Job No.: ANK-112

**Project/Subject: Cannery PUD – December 8, 2009 Planning Commission Hearing
Open Record Comments**

RE: Cannery Square PUD November 3, 2009 Staff Report Recommendation to the Planning Commission (PUD 09-01)

2) Compact parking stall size

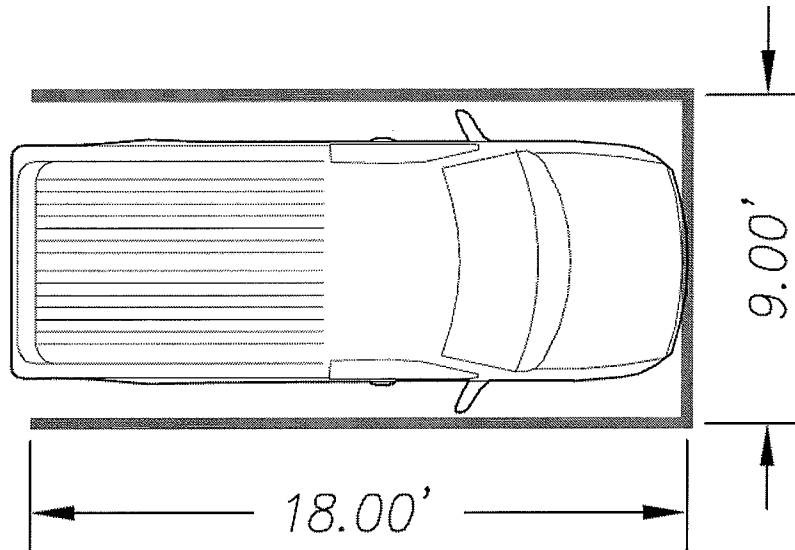
The applicant has requested that a higher percentage of parking stalls be allowed to be "compact." Section 16.94.020-1 defines standard stalls as 9' x 20' and compact stalls as 8' x 18'. The applicant proposes "compact" stalls at 9' x 18' and believes this size is adequate to accommodate larger passenger vehicles. No change in the required 24-foot wide parking lot drive aisles is proposed. Below is a scale drawing of Chevrolet Suburban, the largest likely vehicle to be accommodated, in a 9' x 18' "compact" parking stall.
